Coastal Works Review

**Marriott Beach Resort, Seven Mile Beach Club, South Bay Beach
Club, Plantation Village & Tamarind Bay**

Southern Seven Mile Beach – Shoreline Modification

Refs: DOE/CWK/381, 382, 383, 384 & 385

Figure 1: Cropped image from the applicant's site plan showing the approximate location of the proposed works.

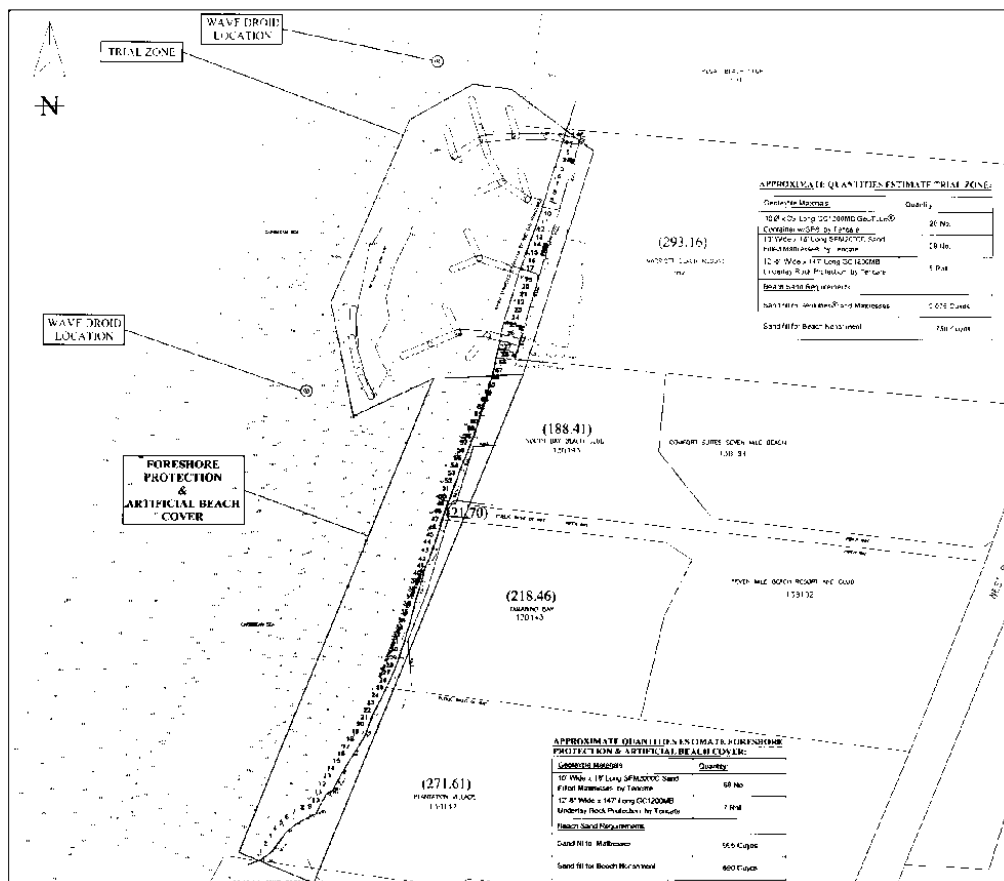
- ***The layout of the geotube groyne field does not make physical sense and is mostly inconsistent with structural designs for beach stabilization/enhancement.** Its dendritic layout is more akin to the roots of a tree intended to hold soil as if on a hillside slope or riverbank; that is, not along an open coastal environment.*

- *The two embayment shapes created by the three southern principal shore-perpendicular groynes (labeled A, B, C in Figure 5) with fish-tail heads, is somewhat consistent with the creation of crenulate pocket-beach embayments (using T-head or fishtail groynes); but the width of the two openings are too small – 40 feet – because this is both uncomfortable for bathers and conducive to cause erosion through a “suck-and-draw” effect of waves moving into and out of an embayment through a narrow opening. (Pocket beach cell openings are usually >70+ ft wide.)*

- *The intermediate spurs near the landward ends of groynes A and C – located within 50 feet from shore – will induce beach erosion (through wave diffraction effects) because they are located too close to, and semi-parallel with, the shoreline.*

- ***The presence of the geotubes, as proposed, does not promote or stabilize the accretion of beach sand.** Instead, it can retard or resist sand accumulation because the geotubes are smooth, reflective surfaces. **They may block the longshore transport of sand (or on/offshore transport in the case of the north-end groynes), but only at the cost of inducing erosion on the downdrift side.** Structures do not manufacture sand; and in an under-nourished or sediment-*

deficient environment (such as this), they may only impound some sand at the detriment to other shorelines. **The overall submerged groyne layout has no rational basis, precedent, or justification.**

- **It is implausible that a 1-ft thickness of sand placed atop the shorefront mattresses in the surf-zone would remain in-place amidst this otherwise erosional environment** – that is, without a beach nourishment project that is much greater than that which is proposed, or without natural sand influx that wholly buries the mattresses with a very much thicker and wider deposition of sand.

- The proposed shorefront mattresses can provide undermining/scour protection along the foundation of the seawalls; but they will not promote a sand beach. Instead, their reflective, impermeable surface will retard natural accretion of sand. Upon construction, the mattresses will displace any sand beach that currently exists, and the post-project shorefront (in absence of major renourishment or significant seasonal influx of sand) will be armoured by sand bags, not a sand beach. A visual example of this is shown in the figure below, where shorefront armoring by the proposed Tencate mattresses was constructed along Kaanapali, Hawai'i. The structures protected the oceanfront walkway but do not provide for a practically usable sand beach. It is an armoured beach. Another example includes Waikiki Beach (c. 2017) – where the mattresses arrested erosion, but the beach in this area is more or less cordoned off from use by the public (per my correspondence with colleagues in Hawaii, this date.)

- *No certain sand source is proposed to fill the geotubes & mattresses – or for beach nourishment – but a suggestion is made that the source may be “local deposits” presumably including the nearshore beach. As such, diverting $2075+995 = 3,070$ CY from the natural beach environment to fill geotubes & mattresses – structures that can be expected to result in beach erosion (or retarded beach accretion) -- appears to be very imprudent.*

- *The plan proposes 750 cubic yards (CY) of beach nourishment along the ~280-ft Marriott shorefront, and 690 CY along the 680-ft southern shorefront. That equates to only 2.7 cubic yards per ft along the Marriott property, and 1.0 cy/ft along the rest. With an active beach profile height of at least 7-feet (seabed at -3.5 ft and berm at +3.5 ft), the Marriott fill of 2.7 cy/ft and the south beach fill of 1.0 cy/ft equates to a maximum beach fill advance of 10.4 feet and 3.9 feet, respectively. The actual advance would be much less than this, because the existing beach along the seawall is over-eroded. Thus, there would be little or no net realized nourishment (widening) of the beach beyond the mattresses; and, indeed, no net cover (burial) of the mattresses.*

- 1) The presently proposed plan is untenable and inconsistent with accepted coastal engineering practice. It will not achieve the described performance. It will be ultimately deleterious to the Marriott, Seven Mile Beach, and the Cayman Islands. The proposed plan should be rejected by the Marriott and by the Government.*

- 2) The preferred and recommended alternative is beach nourishment along the Marriott and southerly-adjacent 680-ft shorefront (about 1000 feet total). A minimum beach fill of 12 cubic yards per ft alongshore (12 cy/ft) would result in a net beach width advance of about 50 feet from the seawall at mid-tide-level (and a reliably dry beach width of at least 15 feet), considering the existing over-eroded conditions. Along the Marriott, that equates to about 3,480 cubic yards of beach fill (2,660 cubic meters). But the project will not function unless built along the entire 1000-ft shorefront. A minimum 12 cy/ft project along the 1000-ft shorefront would equate to 12,000 cubic yards of beach fill (equivalent to 9,180 m³). An overall minimum beach fill quantity of 12,000 cubic yards is recommended.*
